PRODUCT/PROCESS CHANGE NOTICE (PCN)

PCN #: TB-0609-03 DATE: 06-Oct-2006 Product Affected: All square PQFP and TQFP, MLP Dual, QFP-N, VFQFP-N packages shipped in Tape and Reel Date Effective: 06-Nov-2006	MEANS OF DISTINGUISHING CHANGED DEVICES: <input type="checkbox"/> Product Mark <input type="checkbox"/> Back Mark <input type="checkbox"/> Date Code <input checked="" type="checkbox"/> Other Starting 06-Nov-2006
--	---

ATTACHMENT I - PCN #: TB-0609-03

PCN Type: To comply to current EIA Standard (EIA-481-C) requirement.

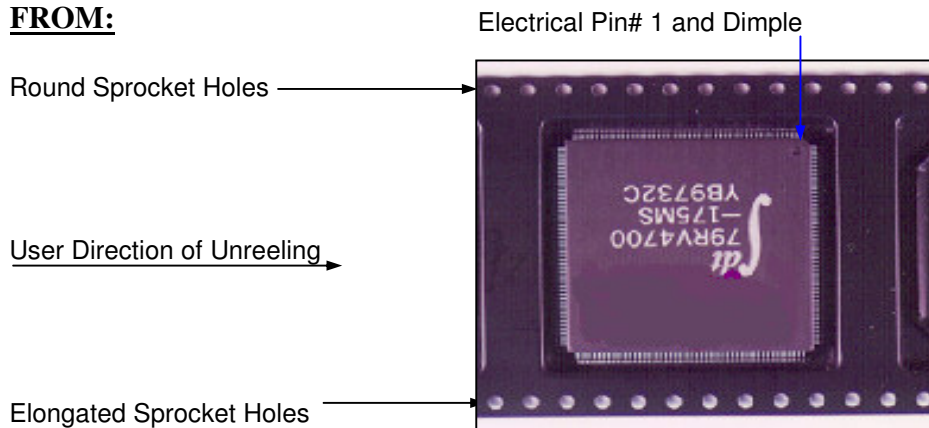
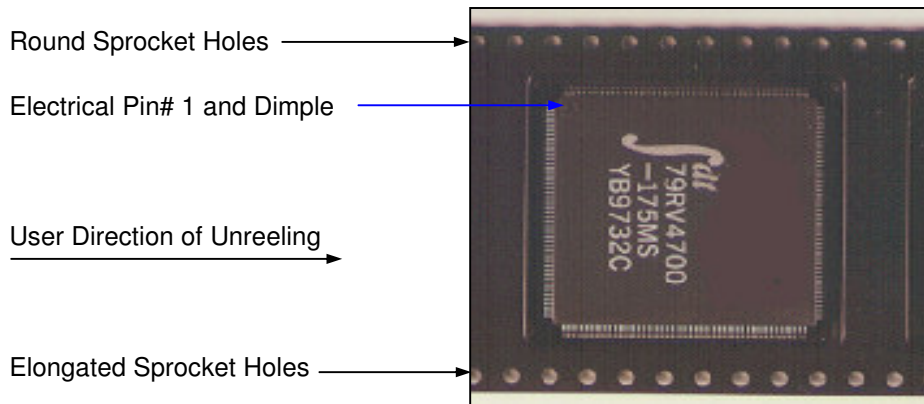
Detail of Change: This change will be implemented on all square PQFP and TQFP, MLP Dual, QFP-N, VFQFP-N packages.

Additional label as shown below will be placed on the intermediate box (pizza box) to alert customer of this change. Label will be placed starting 06-Nov-2006 until 06-Nov-2007. However, please take note that IDT will continue to ship products in existing loading orientation until the inventory has been depleted. Customer may receive shipments in existing or new loading orientation.

● Pin One in Quadrant 1
